10.3 Main Steam Supply System

The information in this subsection of the reference ABWR DCD, including all subsections, tables, and figures, is incorporated by reference with the following departures and supplements.

Figure 10.3-1 Main Steam Supply System

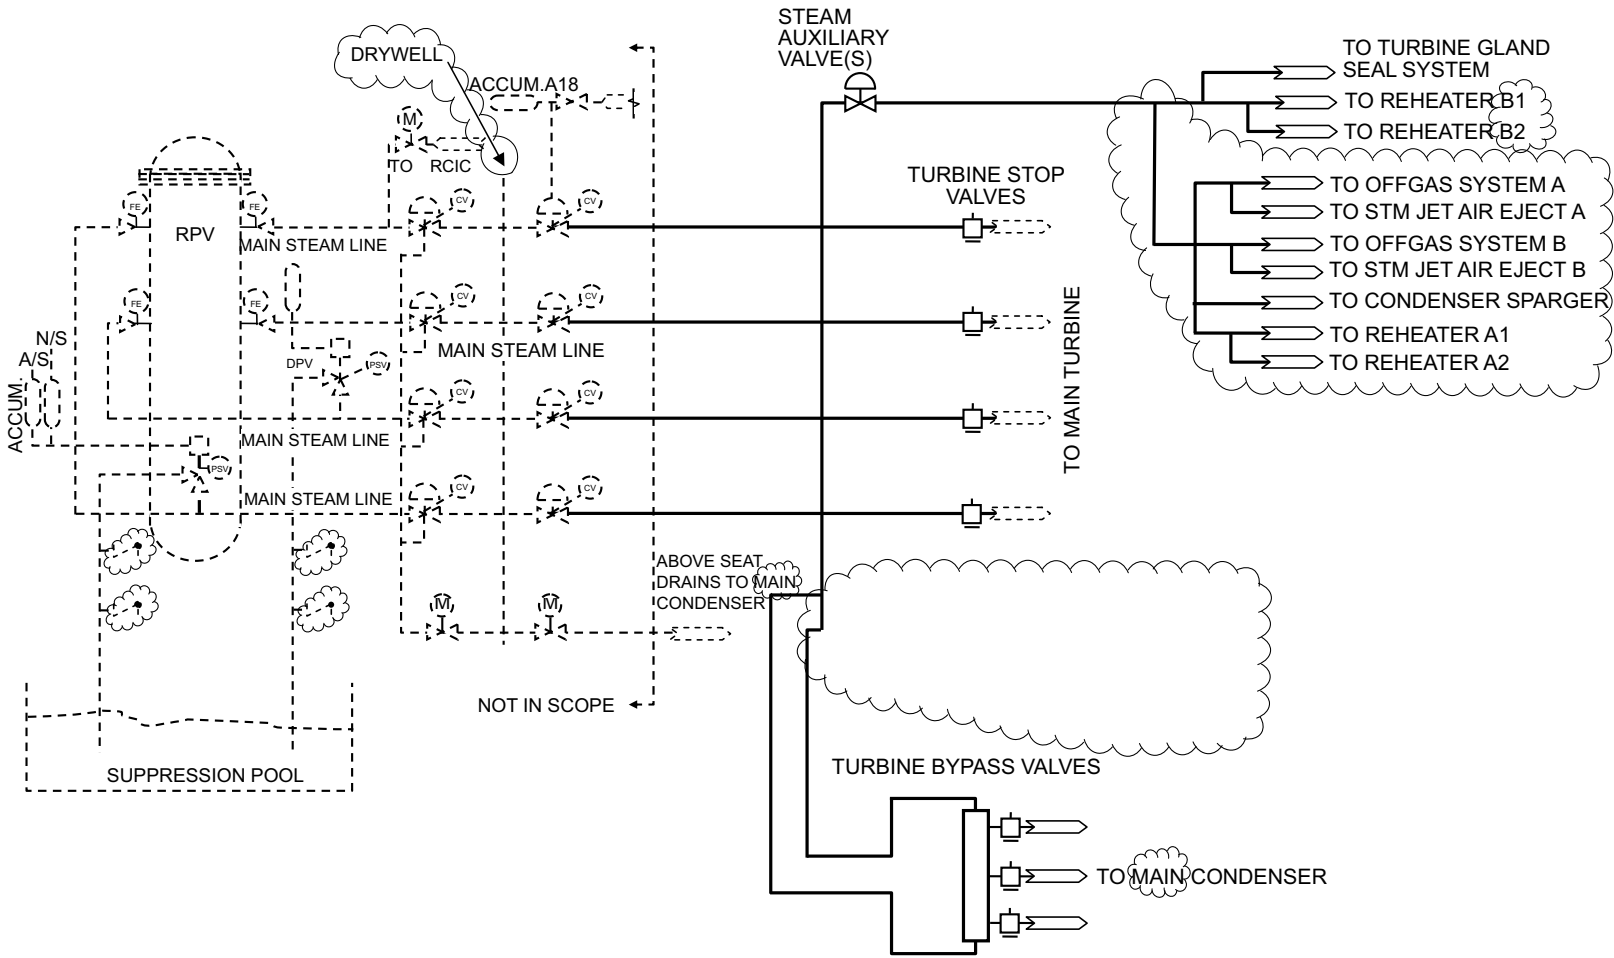
STP DEP 10.2-1 (Table 10.3-1, Figures 10.3-1 and 10.3-2)

The Main Steam Supply System is illustrated in Figure 10.3-1. The system design data is provided in Table 10.3-1. The main steam piping consists of four 700A pipe size diameter lines from the outboard MSIVs to the main turbine stop valves. The four main steamlines are connected to a header upstream of the turbine stop valves to permit testing of these valves ~~the MSIVs~~ during plant operation with a minimum load reduction. This header arrangement is also provided to ensure that the turbine bypass and other main steam supplies are connected to operating steamlines and not to idle lines. The main steam process downstream of the turbine stop valves is illustrated in Figure 10.3-2.

Figure 10.3-2 Main Steam Turbine System

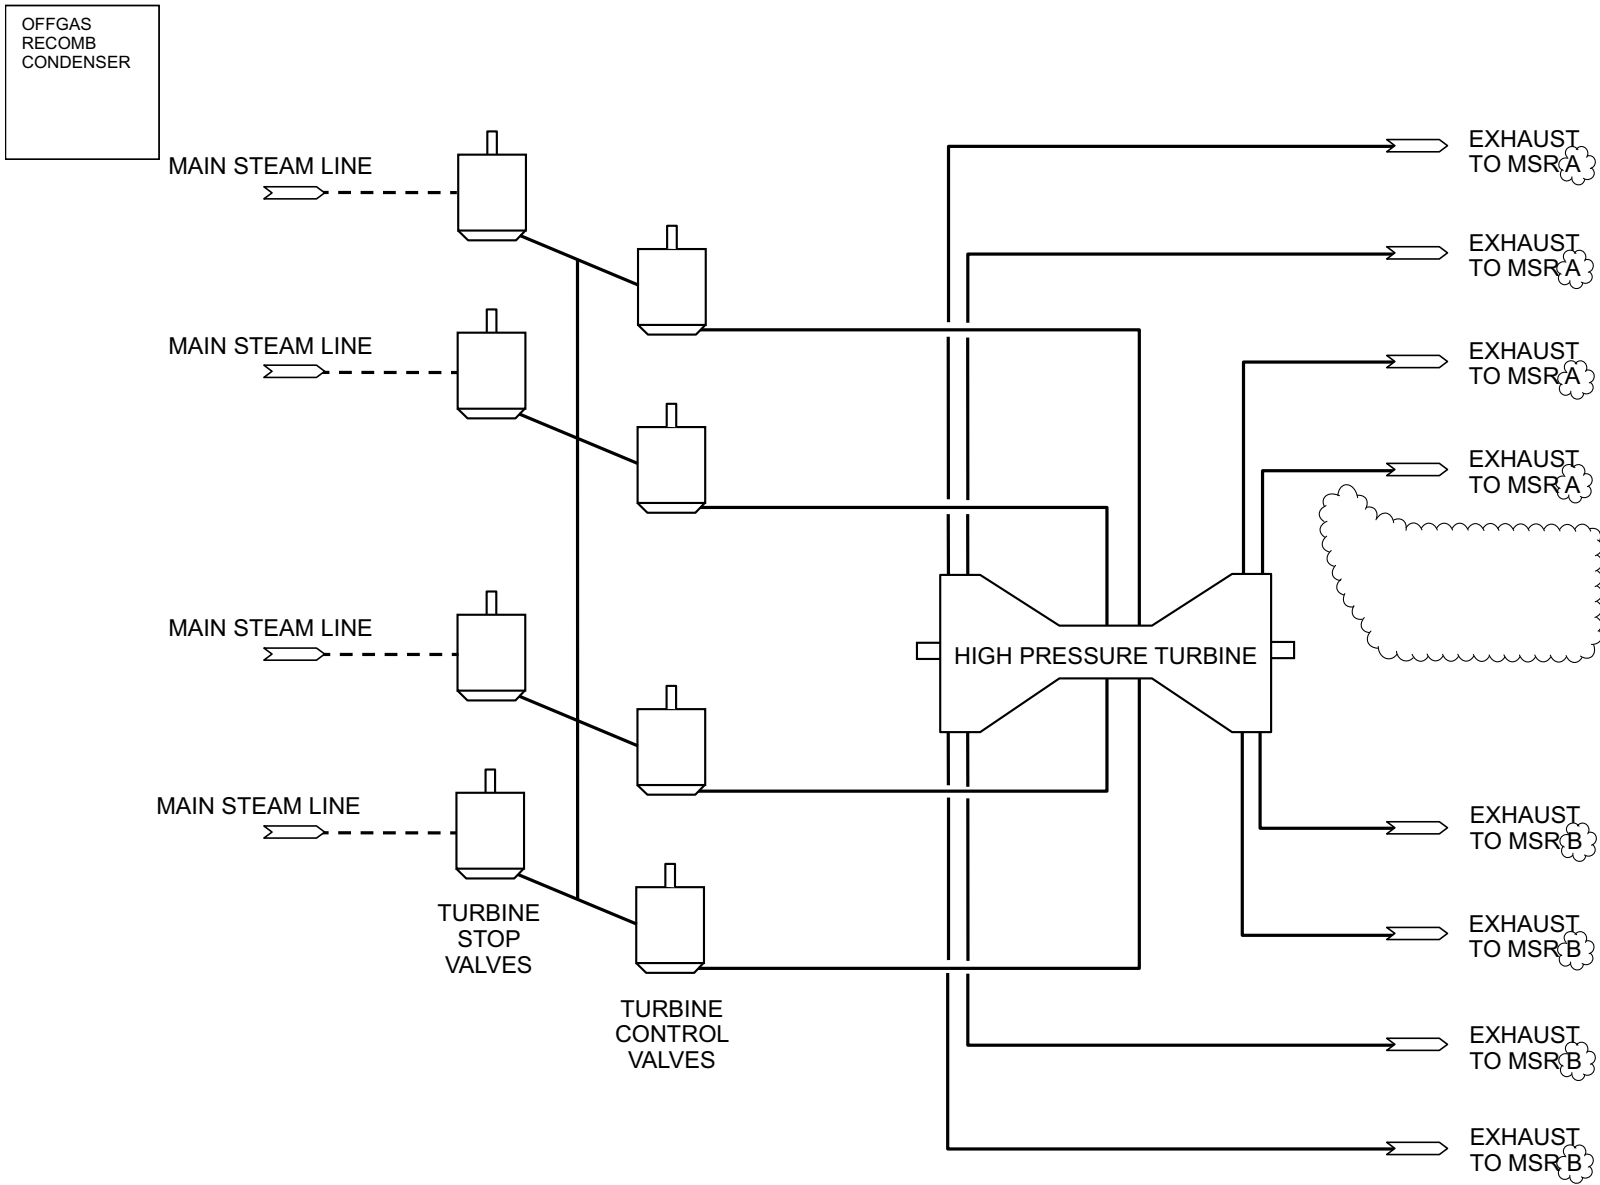
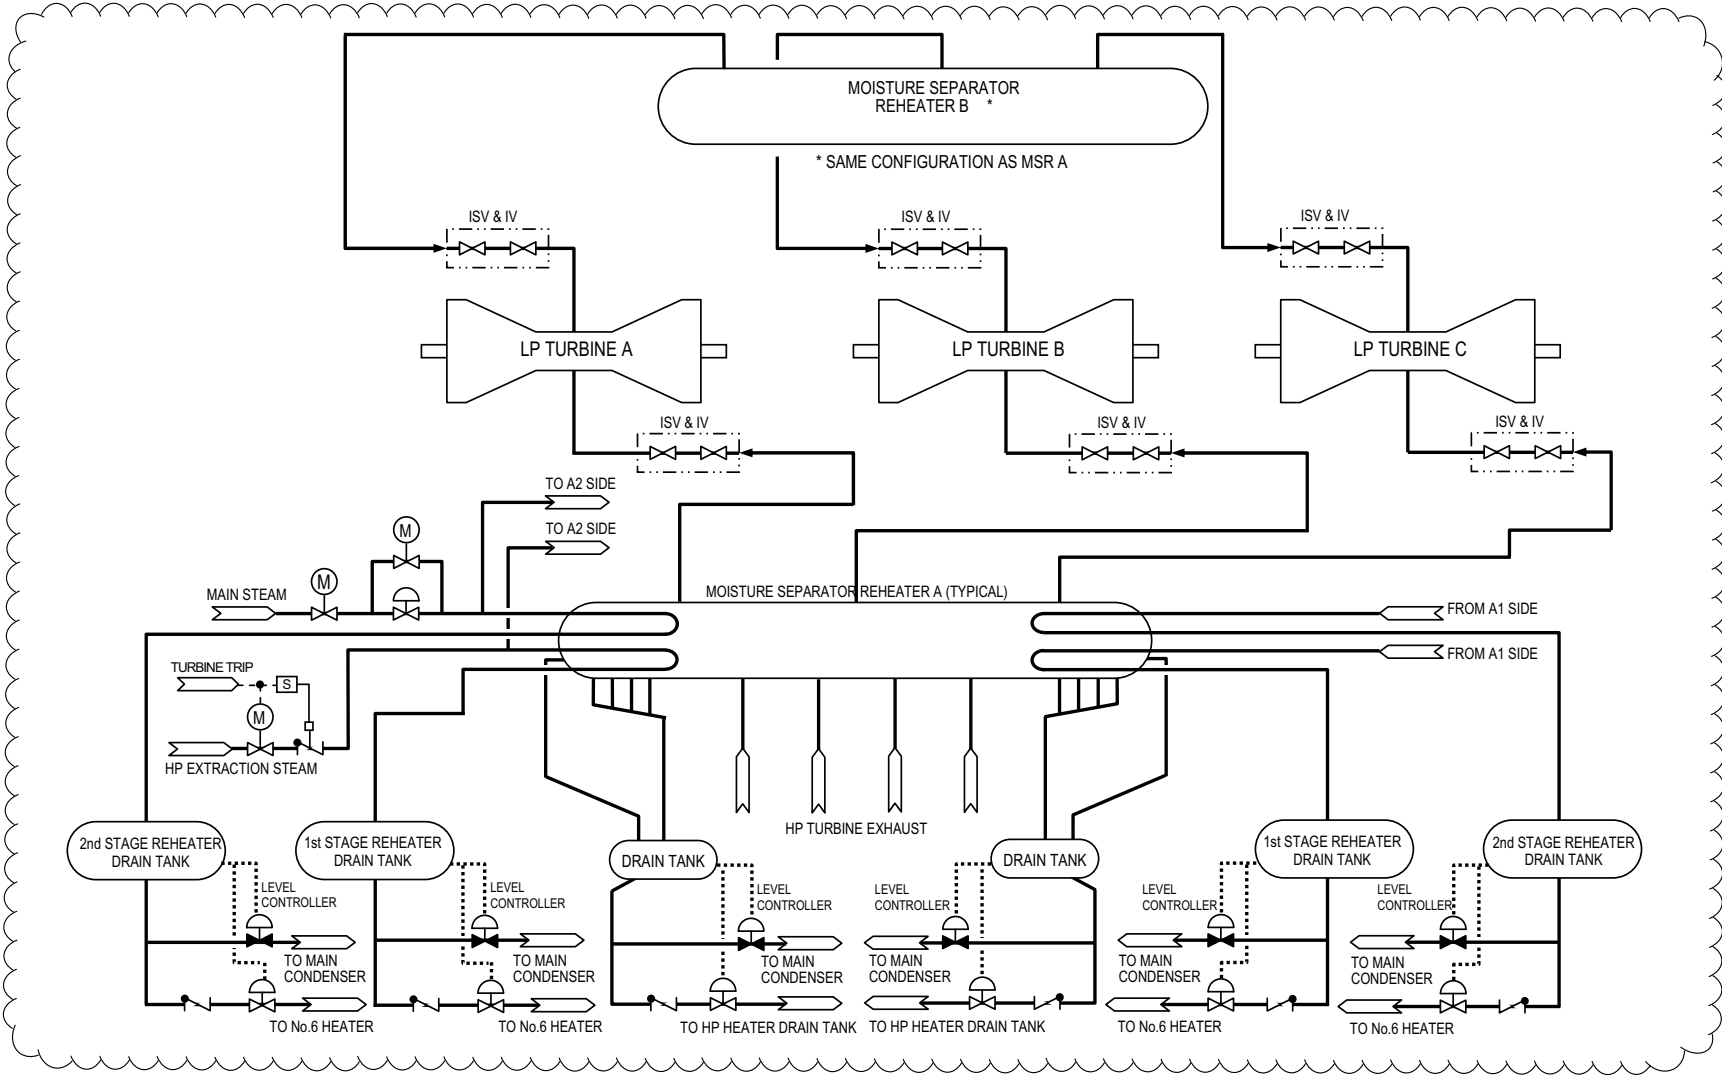
STP DEP 10.4-3 (Figure 10.3-2)
